ODSCC ARC Submittal for Watts Bar Nuclear Plant

**Tennessee Valley Authority
Watts Bar Nuclear Plant
NRC Meeting
7/17/01**

TENNESSEE VALLEY AUTHORITY
WATTS BAR NUCLEAR PLANT
JULY 17, 2001

Type 14 Depth/Length Profile

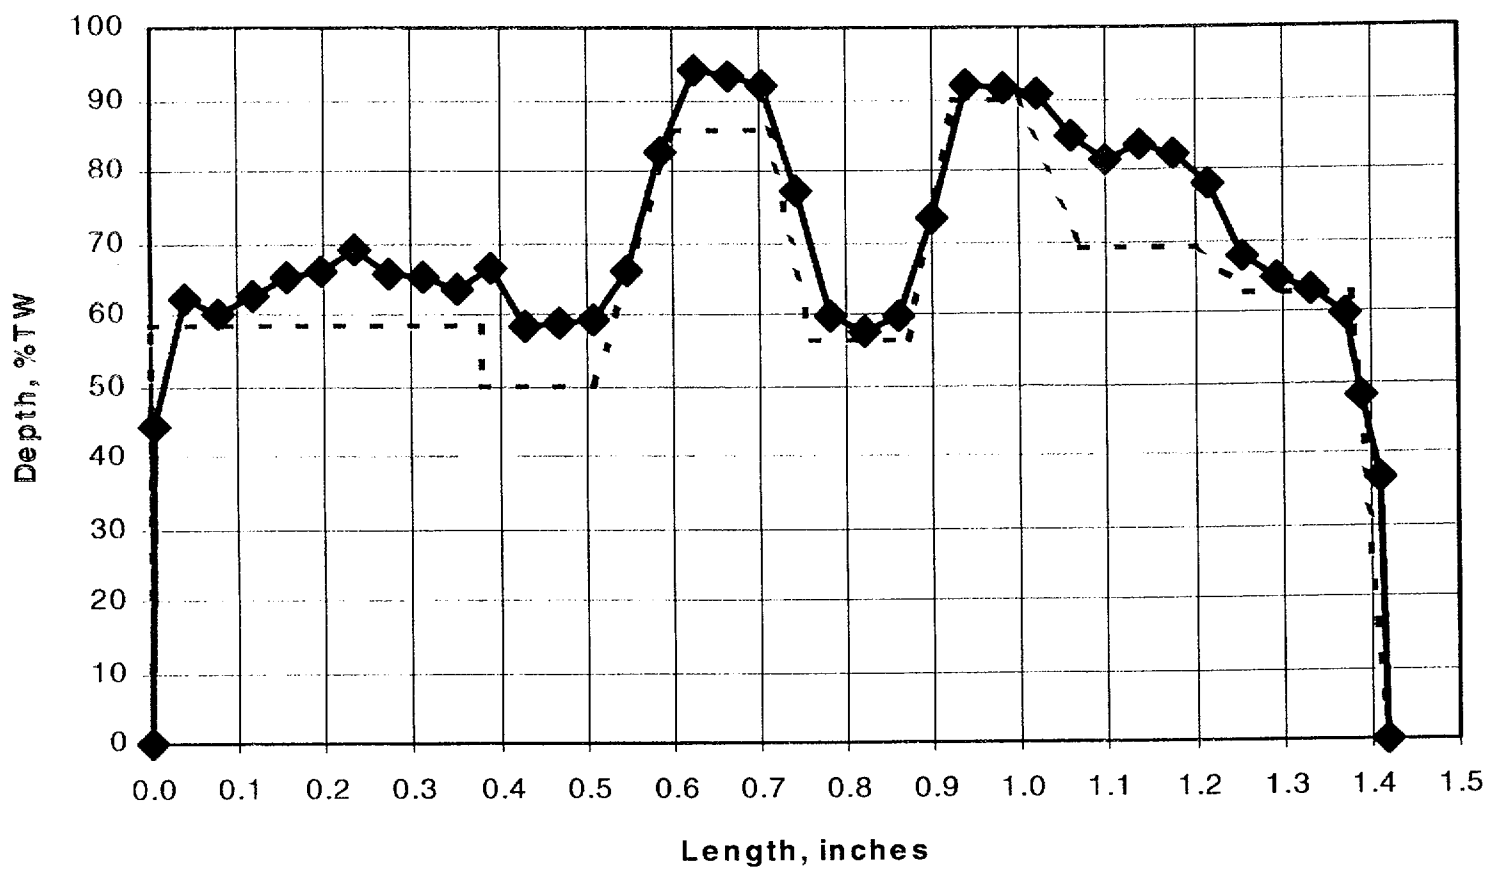
- ◆ TVA needs to address the pressurization rate affect on burst testing tubes that called into question the validity of the burst correlation developed for the voltage-based repair criteria

- ◆ Historical Experience – No measurable rate effect between 200 psi/sec and 2000psi/sec (fast rate)
- ◆ Testing performed by Westinghouse for ANO of long, deep, axial EDM slotted specimens (Type 14 Profile) called this position into question
- ◆ Burst pressures from fast rate tests were on the order of 20% higher than burst pressures from slow rate tests

Results of Foil Strengthening Test

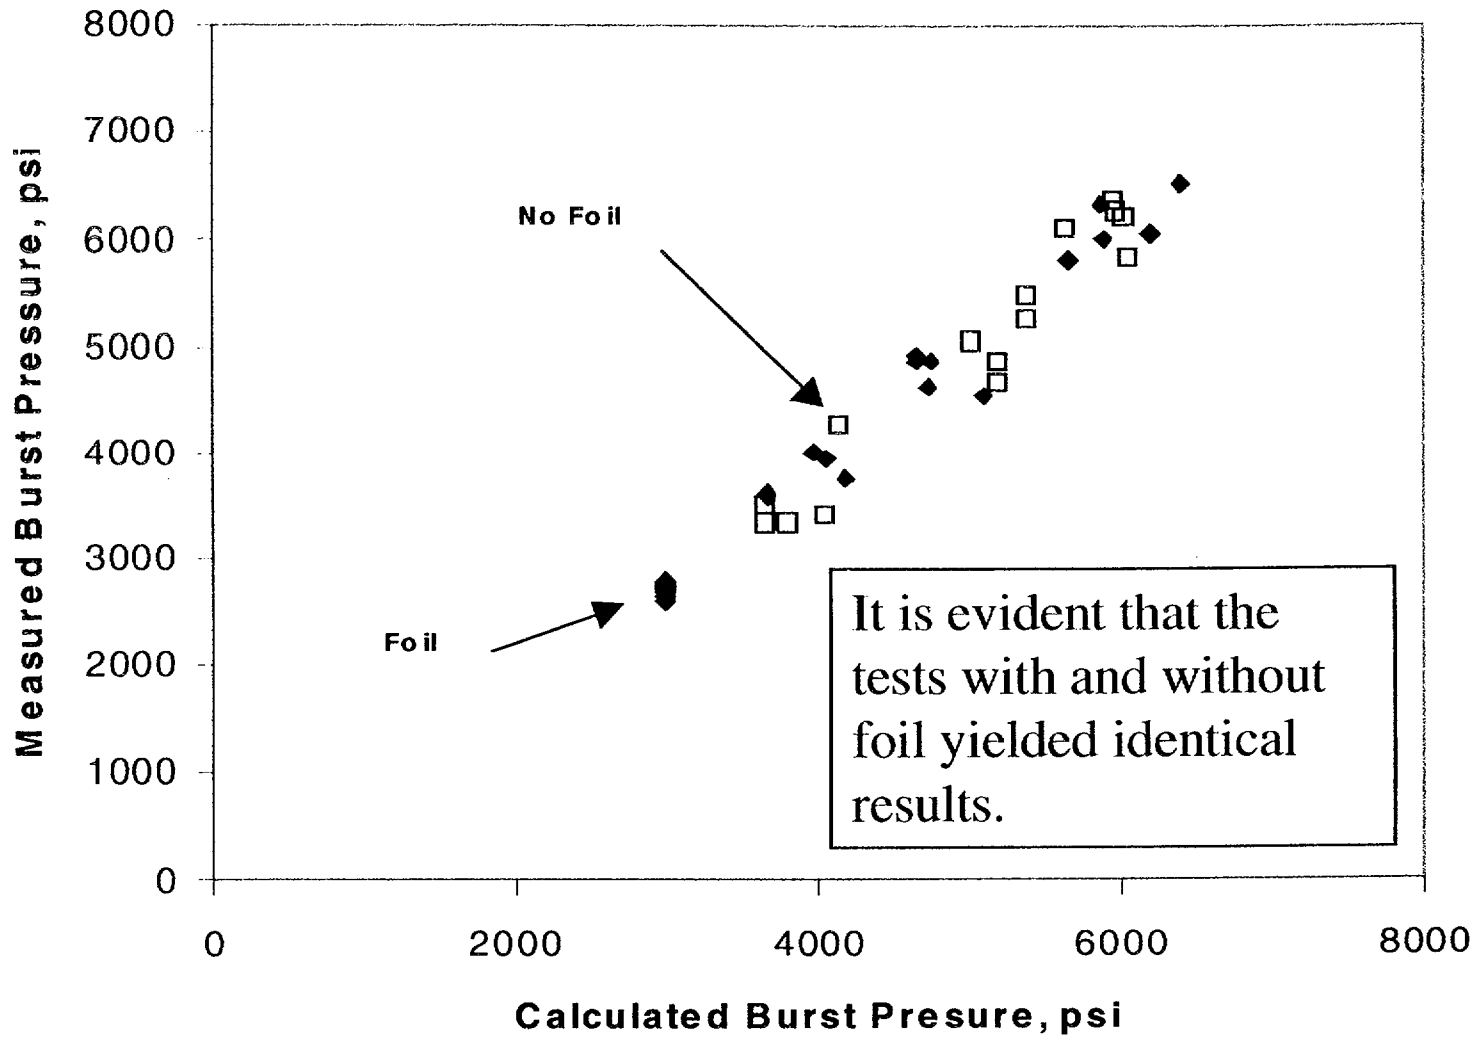
- ◆ There is no measurable pressurization rate effect on the burst pressure of degraded steam generator tubing for pressurization rates between 20 psi/sec and 2000 psi/sec
- ◆ A foil strengthening effect was apparently observed in the original fast rate tests of Type 14 specimens
 - How does the foil strengthening affect the ODSCC database?

- ◆ There is no foil strengthening effect or pressurization rate effect for the data in the ODSCC database
- ◆ Long, part-through wall, axial crack profiles with short, very deep segments may exhibit a foil strengthening effect on burst pressure as exhibited by the Type 14 specimens
 - ARC tubes would not be this size
- ◆ Hold times for in situ tests are still recommended
- ◆ The pressurization rate issue has been resolved relative to the ODSCC database

Figure 1: STP Model
Pre-accident Iodine Spike

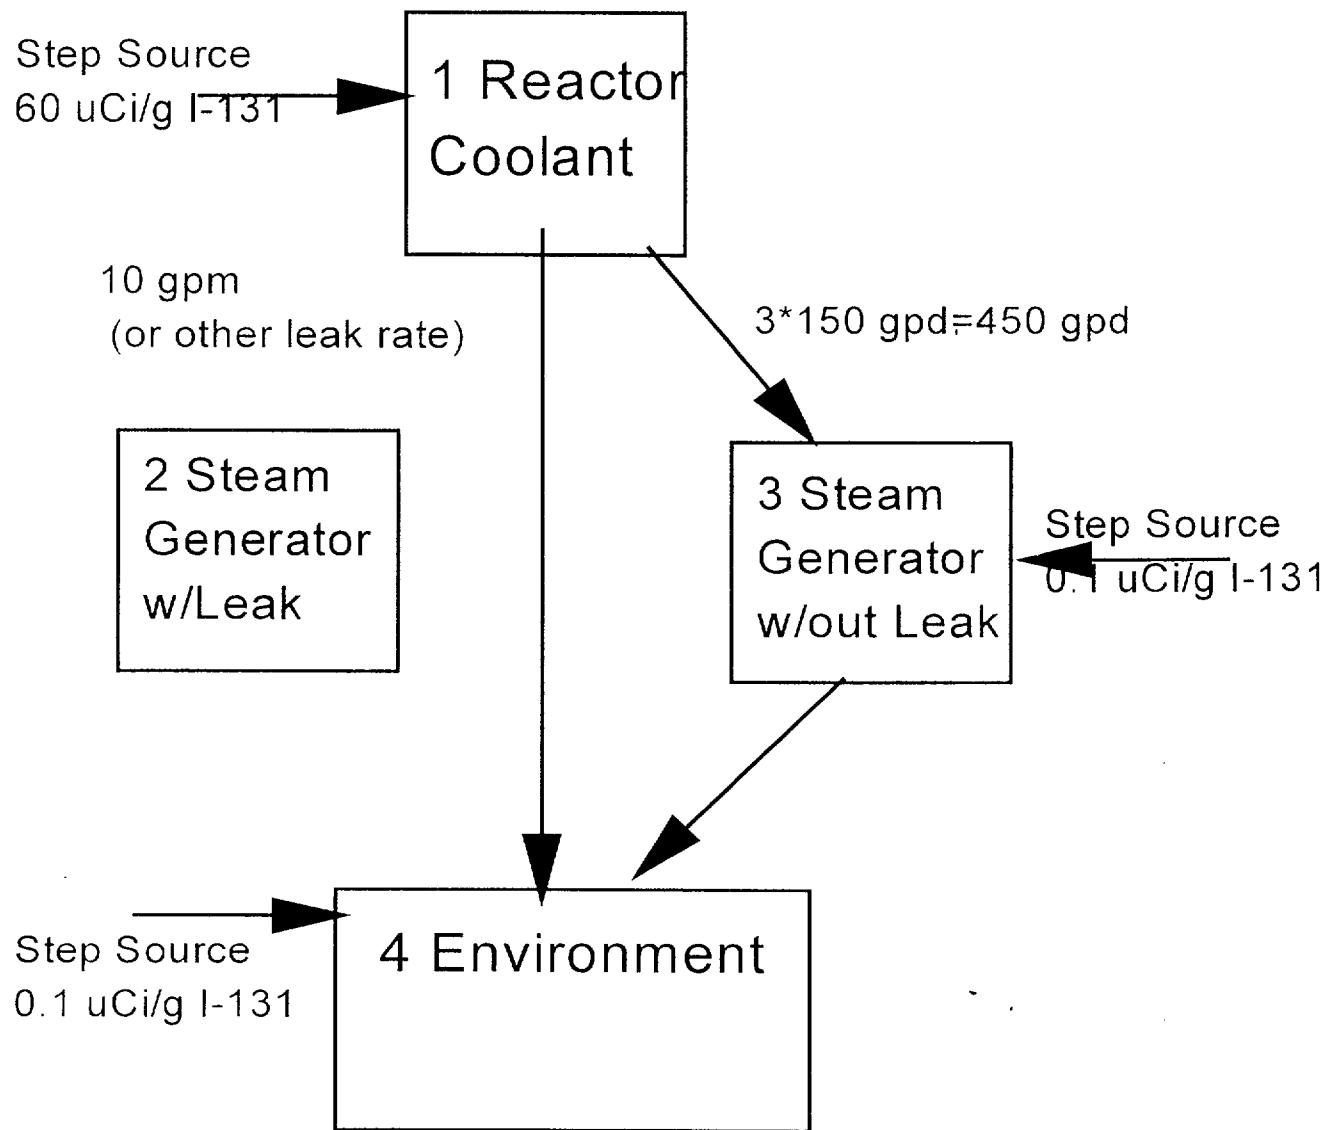
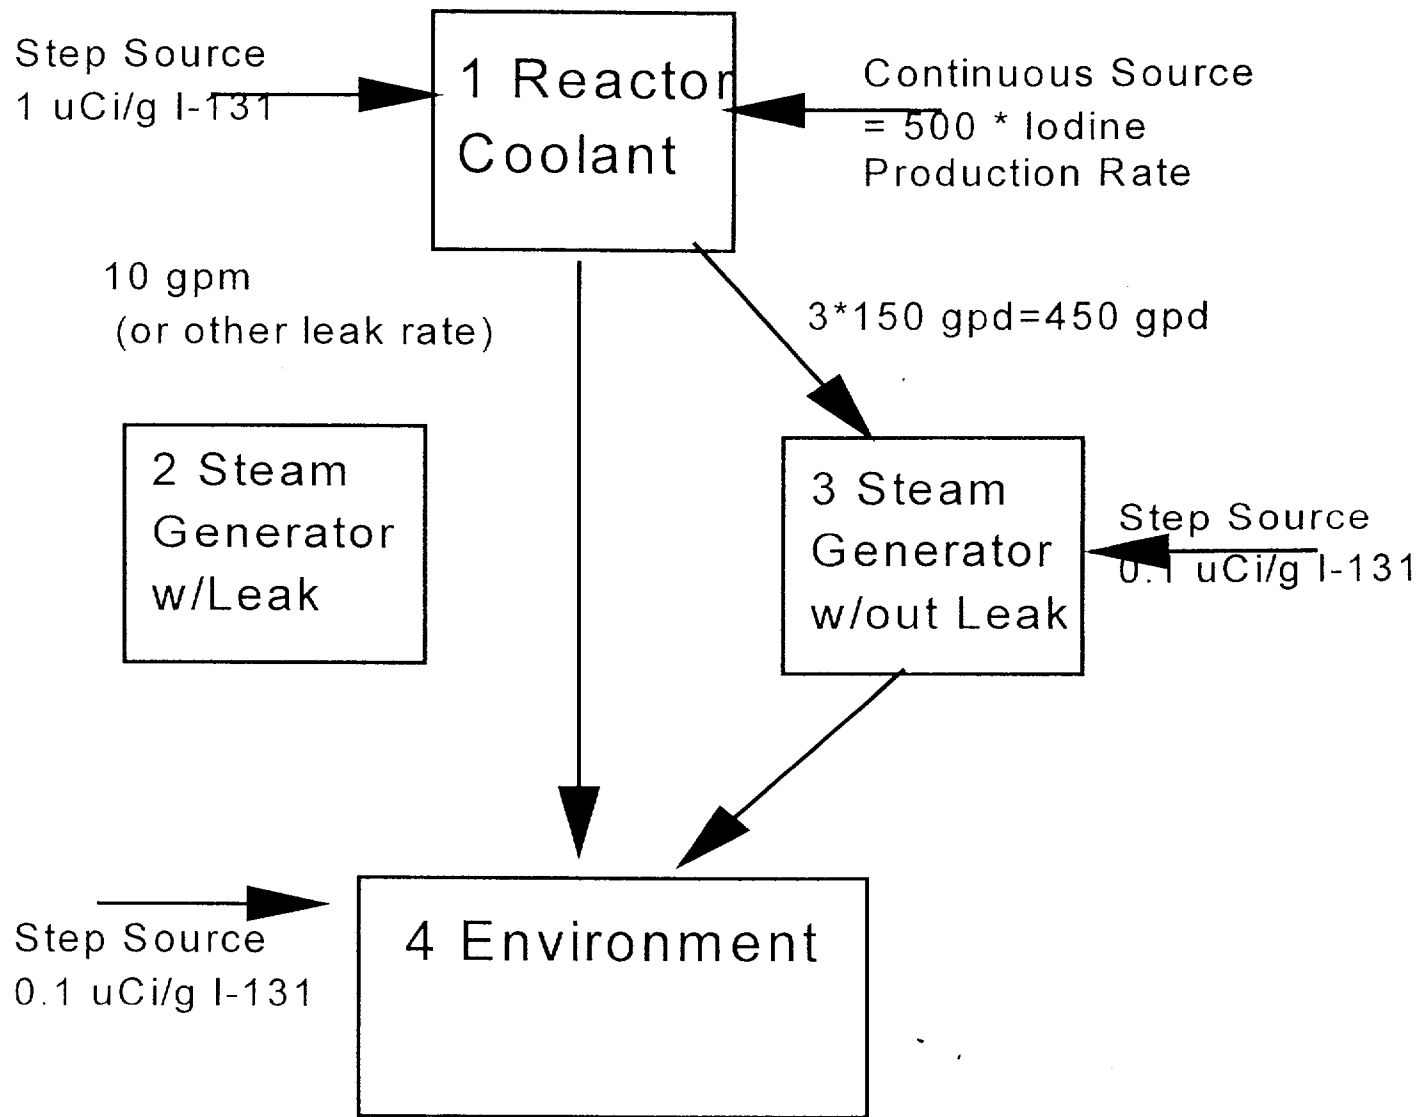
- **Flows of 150,000 lb and 2509 lb should be considered separately since the 150,000 lb is secondary side at 0.1 uCi/gm and the 2509 lb is primary side at a higher concentration.**
- **Response: Agree. The revised calculation model steps the 150,000 lb secondary side into the environment at time 0. The RCS primary side leakage is modeled separately as a flow from the RCS to the environment.**
